Technical Service Bulletin: TSB101099

Released Date: 01-Dec-2010

Crankcase Blowby Measurement Procedure Update

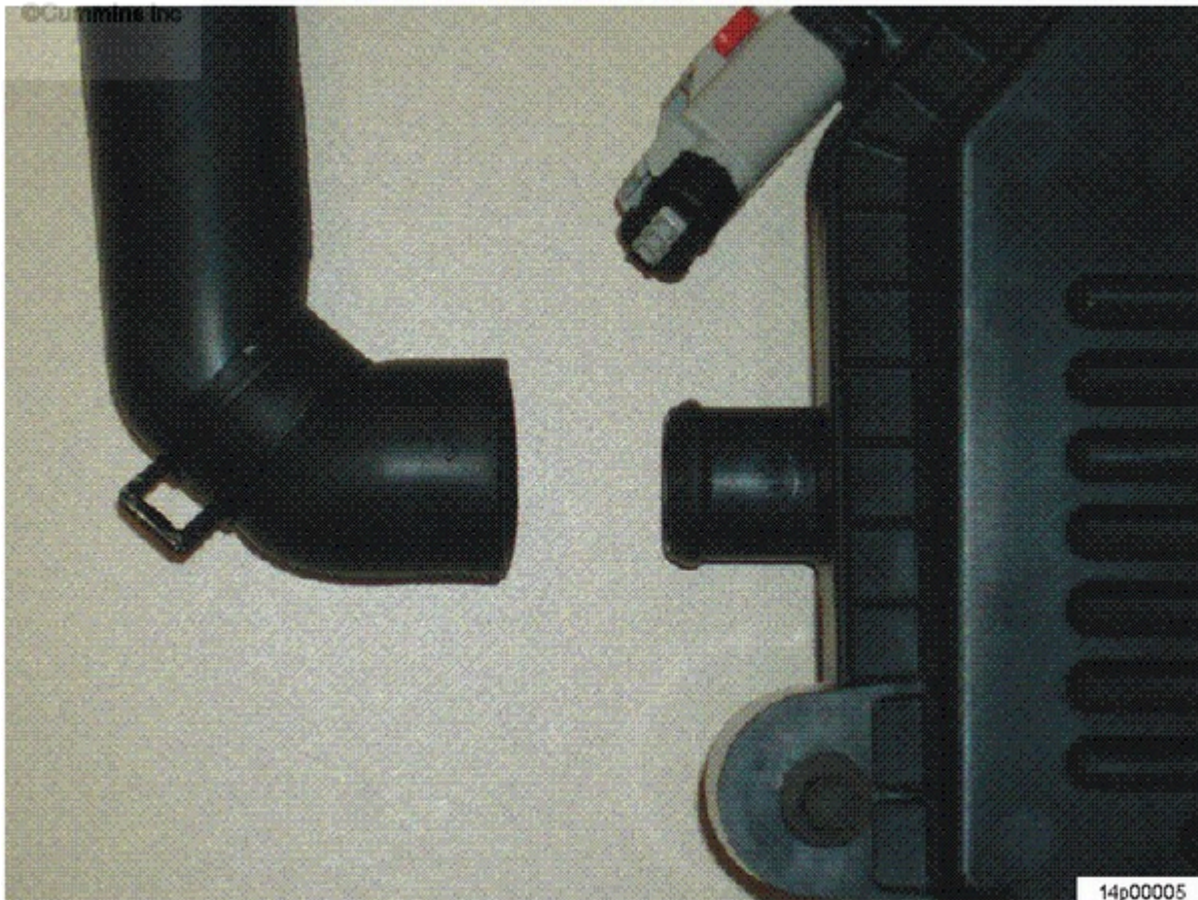
This document announces the addition of specific instructions for measuring blowby on engines equipped with an external coalescent breather filter.

For engines equipped with external coalescent breather elements (ECMs CM871, CM876, CM2250, CM2150, and engines equipped with Enviroguard filters), connect the appropriate blowby service tool to the crankcase breather tube on the inlet side of the coalescent breather housing.

Make sure to install the service tool on the inlet side.

By installing the blowby service tool into the inlet side crankcase breather tube, the potential for inaccurate blowby measurements caused by varying filter restrictions is eliminated.
